Final Value Study Report

I-95/SR-9 from S. of Miami Gardens Drive to Broward County Line Miami-Dade County, Florida District 6

Financial Project ID: 414964-1-22-05
VE Contract No: CAP39
VE Task Work Order: #1
VE Study No. 2400601
Workshop Dates: November 13 to 17, 2023
Final Report Date: July 11, 2024

Deliverable: Value Engineering Study Report
Project: I-95/SR 9 from S. of Miami Gardens Drive to Broward County Line PD&E VE Study
Client: FDOT, District 6
Location: Miami-Dade County, Florida

Figure CO-1-1: Bird Eye View of the Subject Property

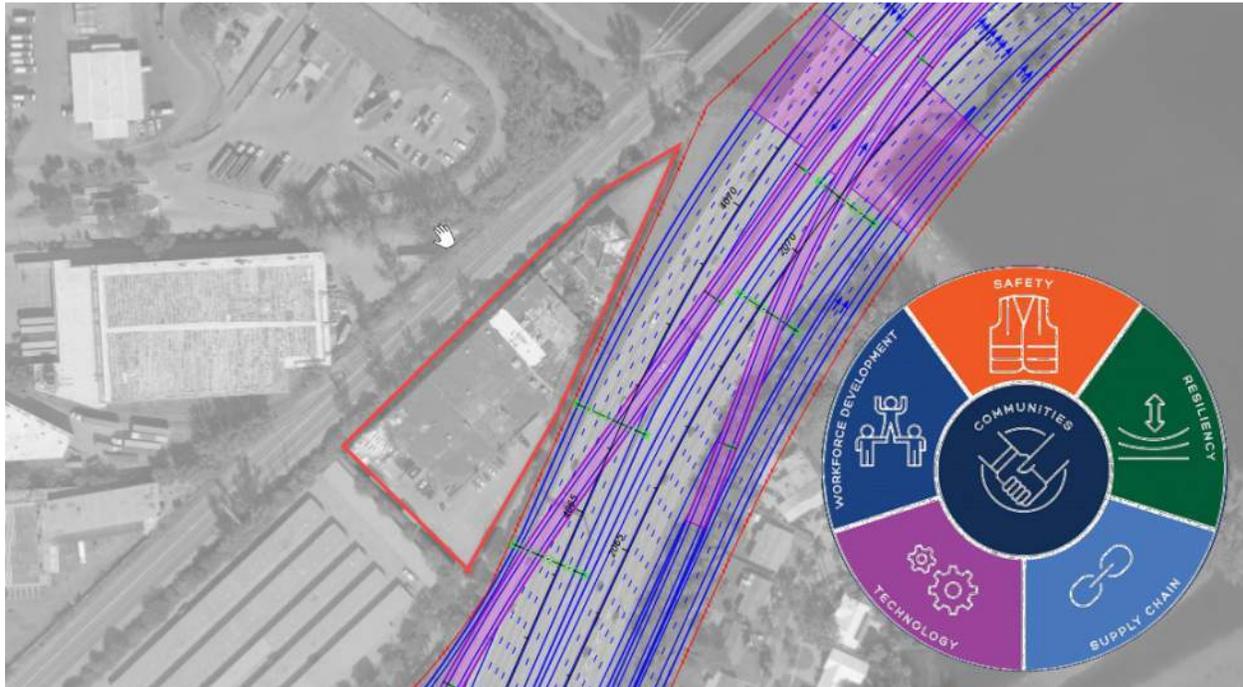
- The property may be used as a staging area during construction.
- The property will also be beneficial to the overall project to provide real estate for realignment, access, and drainage improvements. See proposal RD-4.

- The acquisition of the property will also eliminate the risk factor associated with sound barrier wall.
- In line with the Resiliency, one of the five pillars of the FDOT Compass, this property may be used as a site for parking garage for connected vehicles and autonomous vehicles for future planning. Passing of state law CS/HB311 encourages Florida to attract more business to be interested in the property as well. This created another opportunity for the proper use of this property.

- Provide access and laydown for SB I-95 bridge reconstruction over Snake Creek Canal (C-9).
- Structure could be configured to serve as temporary field office during construction.
- Reduces noise abatement accommodation that may otherwise be needed at this property.
- Future use could include stormwater attenuation, treatment, and/or infiltration.
- Future use could include providing wider shoulder and clear zones, designated emergency stopping site, and/or crash investigation site.
- Location is not within residential neighborhood and could be used for autonomous vehicle parking or testing site in the immediate future.
- Reduces risk of schedule and budgetary impacts to the project if the property is redeveloped. Targeted early acquisition would mitigate this risk.

Figure RD-1-2: PD&E Preferred Alternative – SOUTHBOUND Braided Ramp Access

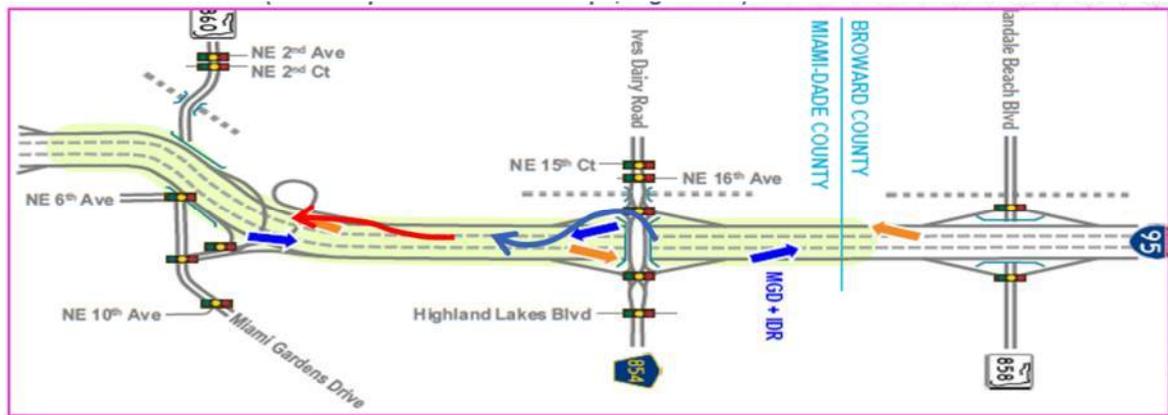
The VE team proposes to eliminate the first northbound braided ingress ramp (i.e., just north of MGD). Secondly, the VE team proposes to eliminate the southbound braided egress ramp south of IDR, and to replace it with an at-grade slip ramp egress and increase the physical length of the toll zone to at least match existing conditions today.

- Reduces the scope of tolling infrastructure to operate the express lane facility (quantity of OH signs, dynamic message signs, CCTV cameras, , and one (1) toll building).
- Matches GGI Ultimate vision to remove both the 2N and 2S access points due to converting GGI Flyover from 1-lane to 2-lanes.
- Mitigates driver confusion at MGD NB.
- Creates typical section space for other required project disciplines (e.g., drainage).
- Eliminates need for ROW take at West Lake.
- Improves response time for incident management events.
- Mitigates operational EL closures due to accidents on the single lane braided ramps.
- Provides additional southbound MVDS sensors to support TMC operations (improving system resiliency).

Figure RD-3-3: PD&E Preferred Alternative I-95 Ramp Configuration at MGD

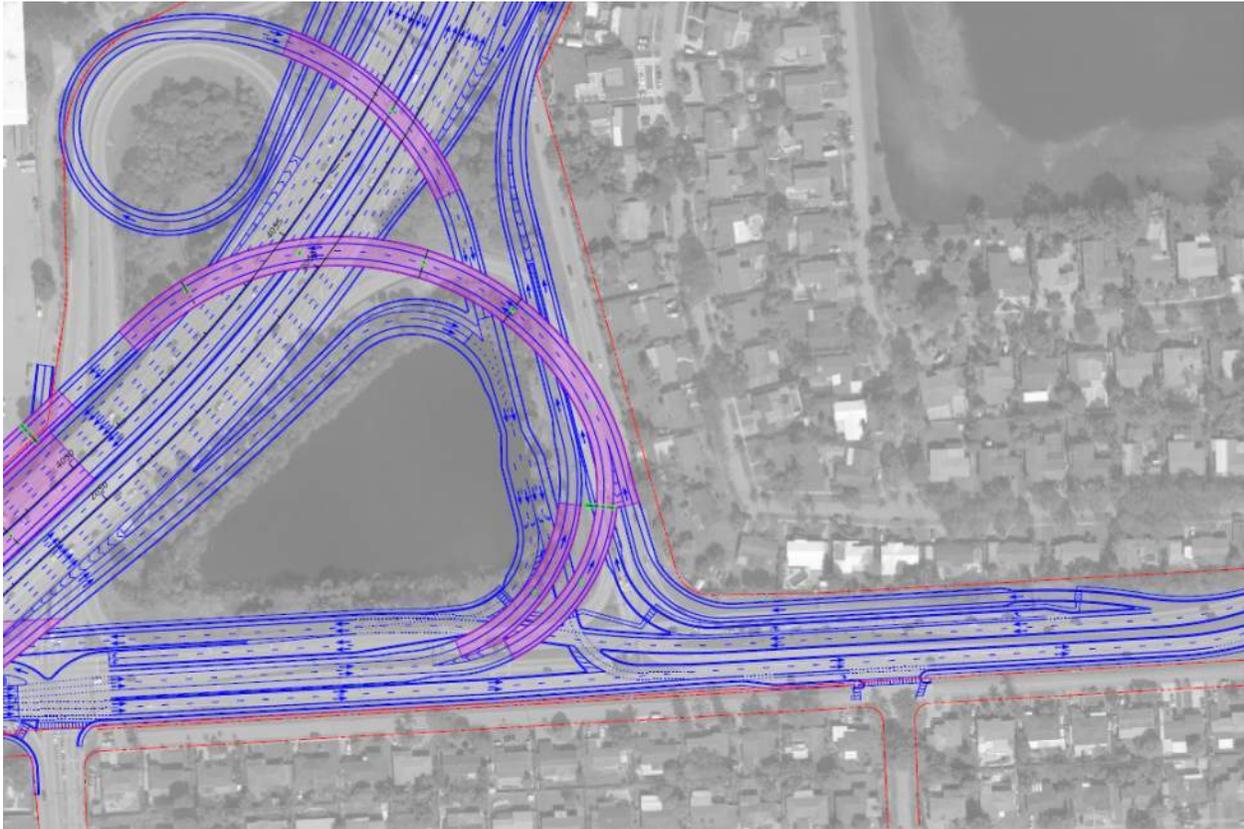
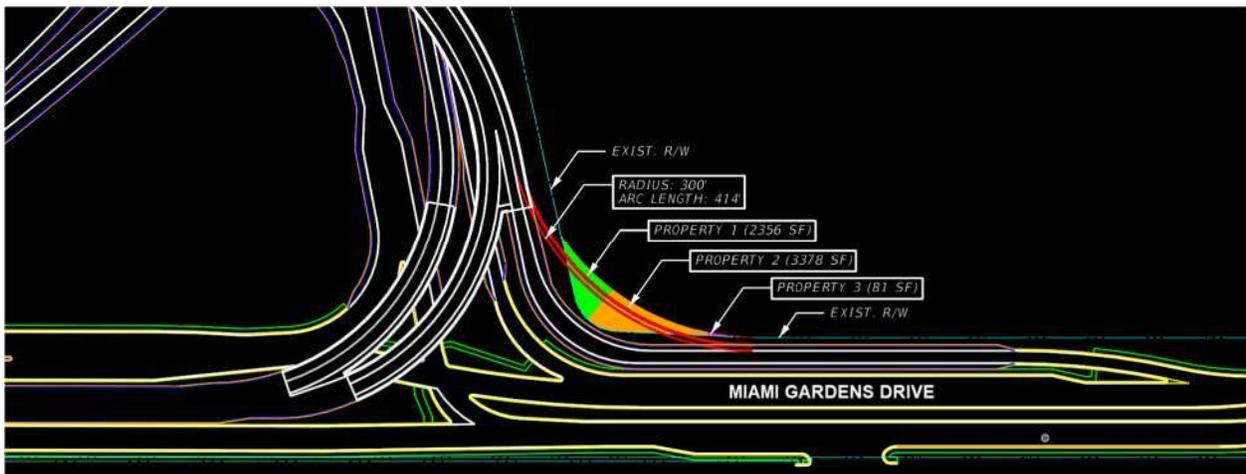
The VE team proposes acquiring portions of the corner properties in the NE corner of Miami Gardens Drive at the entrance of the onramp. The use of this corner cut is to provide a 30mph design curve for these onramps, eliminating design exceptions and creating consistent buffer zones along the north side of the MSE wall along the ramp. The newly proposed radius of the onramp would be 300’, meeting design criteria for a 30mph horizontal curve. The R/W impact would be roughly 5815 square feet.

- The design team would have more R/W space to further improve the preliminary design.
- Eliminates design exceptions.
- Consistent buffer zone.
- Added space for future staging and/or bridge/roadway maintenance.
- Improved stopping sight distance.
- Improved safety.
- Provides a better consistency in traffic flow.

RD-3	WB MGD to NB I-95 use corner cut to provide 30mph design curve to eliminate design exception and create consistent buffer zone along north side of MSE wall at ramp WB MGD to SB I-95	10	(\$192,000)	Accept	The PD&E team will design the WB MGD on-ramp to NB/SB I-95 to provide a 30mph design curve to eliminate a design exception; R/W acquisition will be needed to accommodate this proposal	X		X		
RD-4	Move SB I-95 exit taper just south of Snake Creek Canal (C-9), provide flyover lane in lieu of loop to gain elevation (with Idea #8 and/or Idea #17)	0	\$0 or (\$13,246,000)	Partially Accept	The PD&E team will reconfigure the MGD interchange to modify the SB off-ramp; but will not move exit south of canal	X		X		
RD-5	Keep EL exit braided ramps, provide EL entrances from mainline (eliminate entrance braided ramps)	-6	\$18,989,000	Reject	The PD&E team will not implement this proposal as the traffic LOS fails with having at-grade express lane entrances		X		X

Figure RD-4-3: PD&E Preferred Alternative Loop Ramp / Flyover

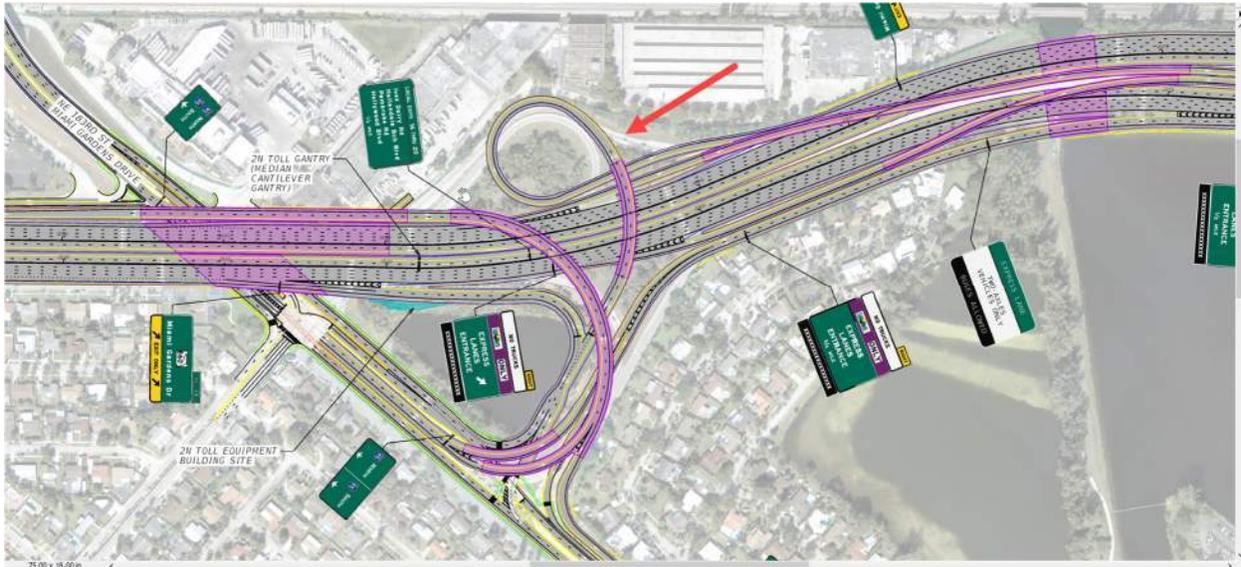
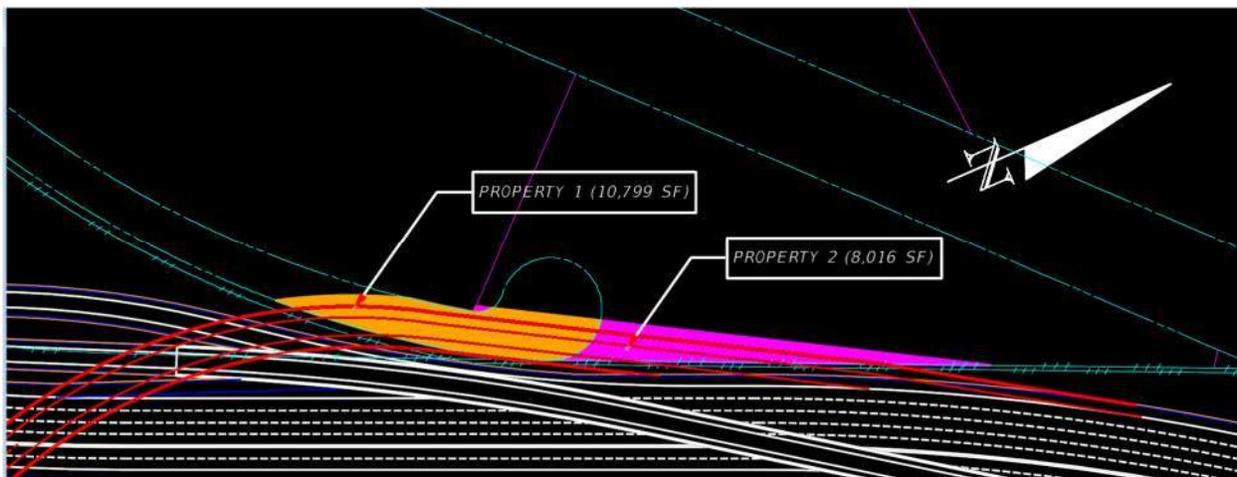
The VE team proposes to reconfigure the SB I-95 exit ramp by moving the exit taper further north to just south of the Snake Creek Canal (C-9). This would provide the space needed to create a flyover lane in lieu of the loop in the PD&E preferred alternative. One of the biggest considerations with this proposal is R/W space needed to implement this alternative arrangement. This proposal would best implemented in tandem with proposal RD-1 (optimize EL access at MGD) and/or proposal CO-1 (acquire sections of the church property to the west). Proposal RD-1 would save approximately 75 feet which could be used for this exit ramp to gain elevation for the flyover. Additionally, the property to the west detailed in proposal CO-1 would could be used provide the space needed for the exit ramp flyover. The VE Team has also calculated the worst-case scenario if both of these other proposals are rejected. Based on design criteria, the flyover would still meet requirements for a 30mph exit ramp. A design variation would be avoided if R/W space is acquired to the west. Additionally, the exit ramp is reduced roughly by 800 feet.

Figure RD-5-1: PD&E Preferred Alt., EL Exit & Entrance Ramps Crossing Between MGD and IDR

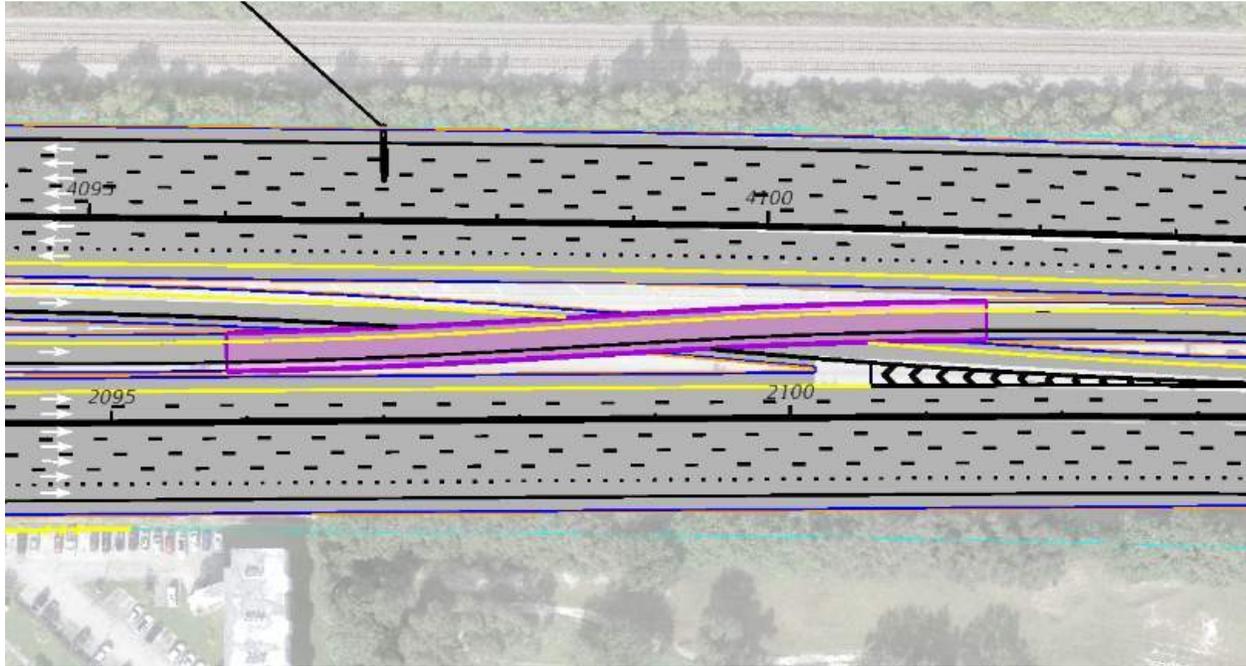
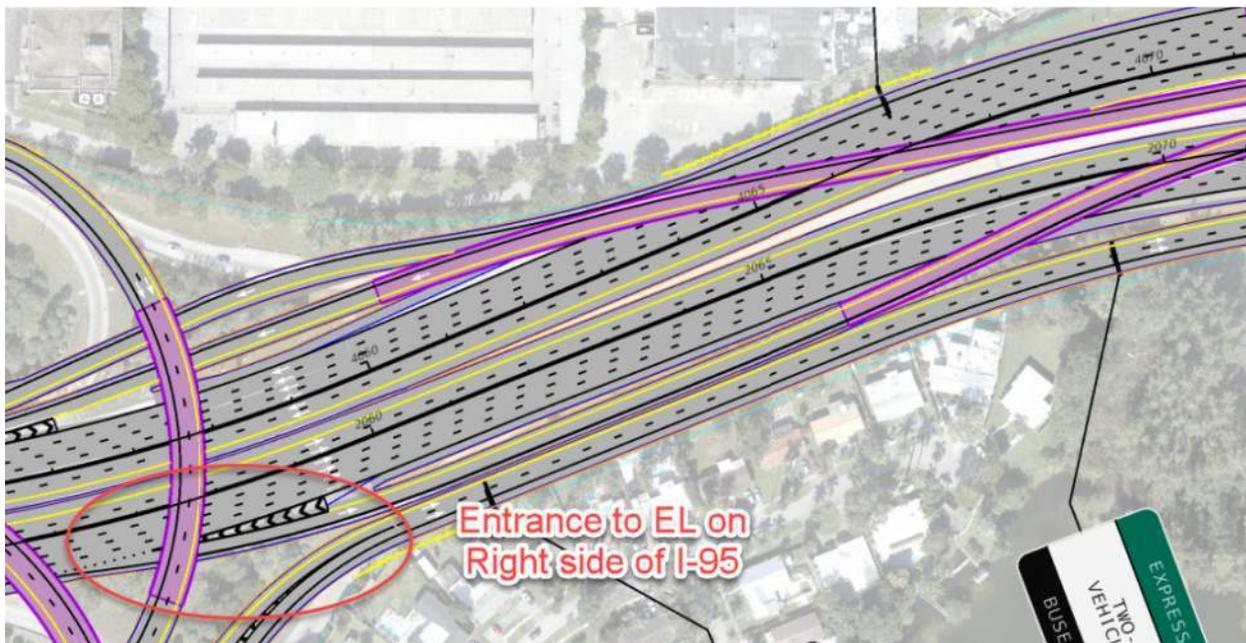
The VE team proposes to remove the ramps that would provide the greatest design and construction challenges to the project. This recommendation suggests removing either all the express lane braided entrance ramps and provide only at-grade entrances or to removing all the braided exit ramps and providing exits that are only at-grade. The VE team recognizes that much of the weaving would occur when drivers exit the express lanes and attempt to cross 4 to 5 lanes of traffic to make their upcoming exit. The weaving that is reduced through the use of braided express way entrance ramps might not be necessary.

- This VE proposal may require the department to approve more at-grade entrances to the express lanes if studies show they are needed in this corridor.

Figure ST-1-3: PD&E Preferred Alternative Trail Section Beneath I-95

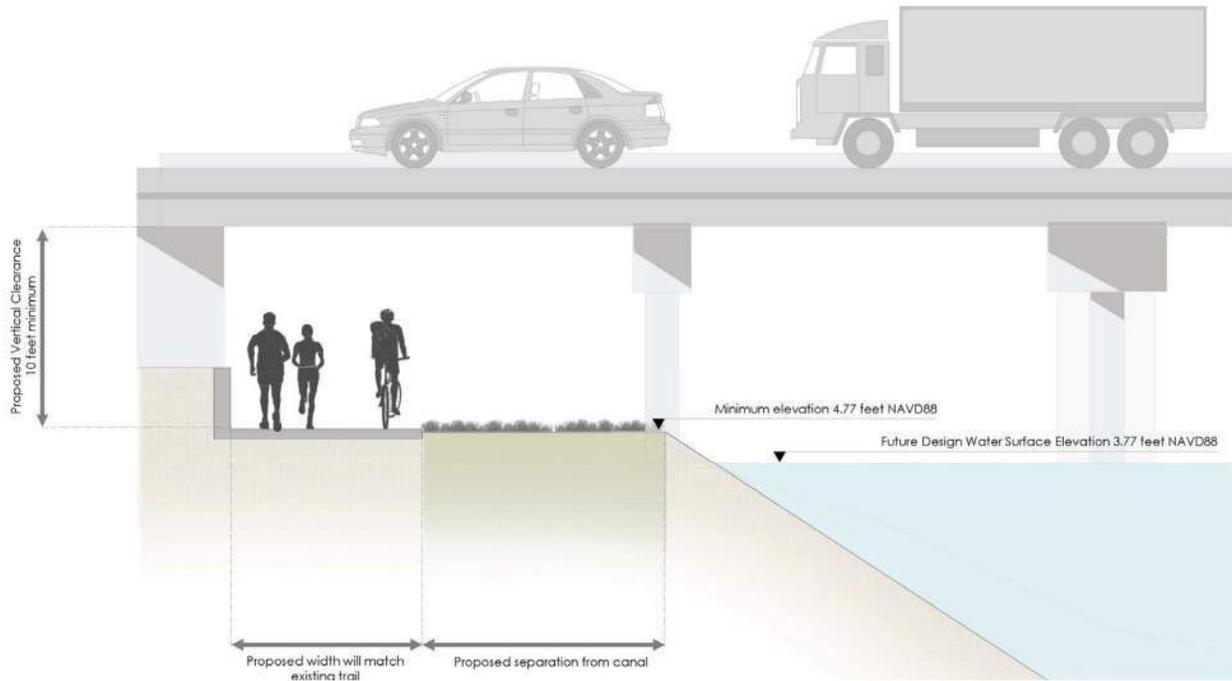
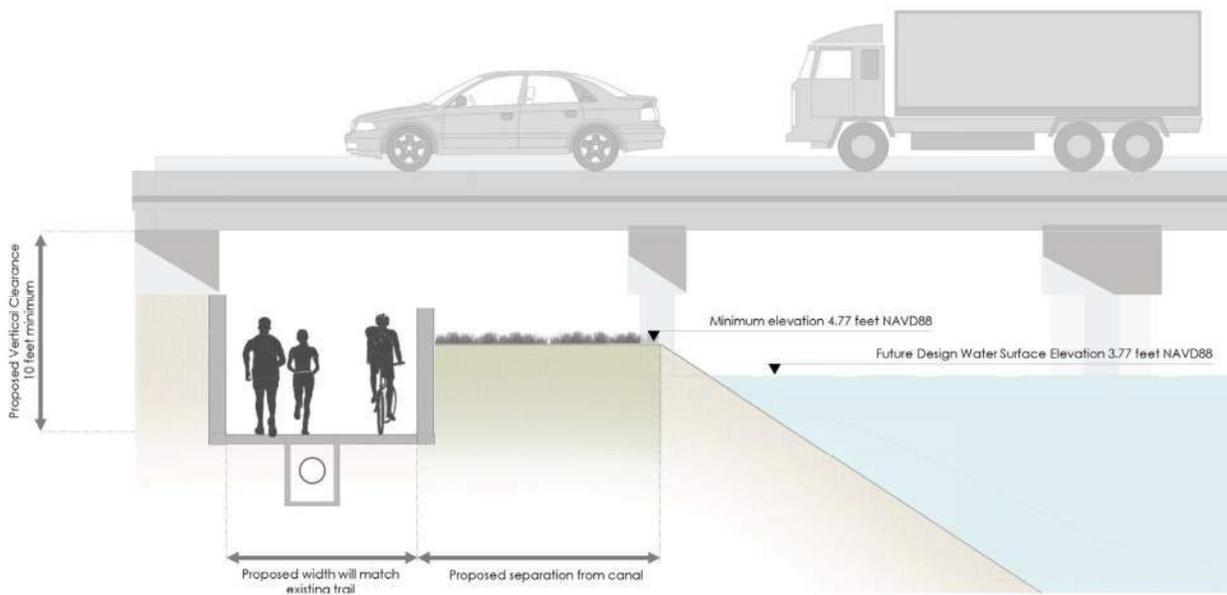
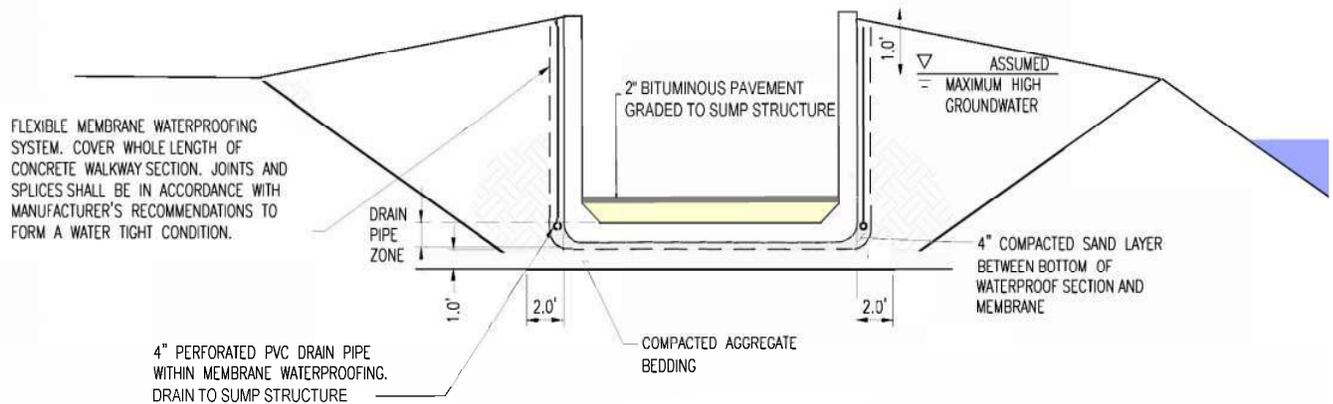
The current PD&E's Team's preferred alternative proposes raising the profile along I-95 by approximately 8 to 10-ft in order to accommodate raising the profile of the pedestrian trail currently running underneath I-95 and parallel to the C-9 Canal (Snake Creek). This would provide the minimum 10-ft vertical clearance required along the entirety of the trail underneath the bridge, would add additional path elevation to address freeboard requirement of 1-ft above future design water surface elevation of the C-9 Canal, and would address ponding issues that occur at the lowest point of the trail underneath I-95.

- Construction cost basis reflects the LRE estimate at the time of this VE Study.
- PD&E study raises I-95 crossing at C-9 Canal (Snake Creek), therefore lowering of the profile will result in earthwork savings. MOT cost savings are anticipated, but are not included in this estimate.
- Structures quantities for spans of bridge should remain roughly the same, bridge spans should not change significantly.

Structural										
ST-1	Lower Snake Creek Trail vertical profile crossing beneath I-95 to reduce roadway impacts	0	\$2,221,000	Reject	The PD&E team will not implement this proposal as the profile of I-95 is influenced by other geometric criteria and constraints; lowering the profile of the trail did not reduce impacts	X			X	
ST-2	Reconfigure NE 5th Ave beneath SB I-95 ramp to reduce SB I-95 bridge length crossing MGD	-2	\$7,226,000	Reject	The PD&E team will not implement this proposal as it would result in R/W and access impacts to private property				X	
Traffic										
TR-1	Provide pedestrian signal at MGD at NE 9th Court, eliminate sidewalk on the north side between 6th Ave and 9th Court and extend south side sidewalk east to NE 10th Ave	2	(\$131,000)	Reject	The PD&E team will not implement this proposal as a midblock signal is already being proposed west of NE 9th Court closer to Milton Littman Park	X
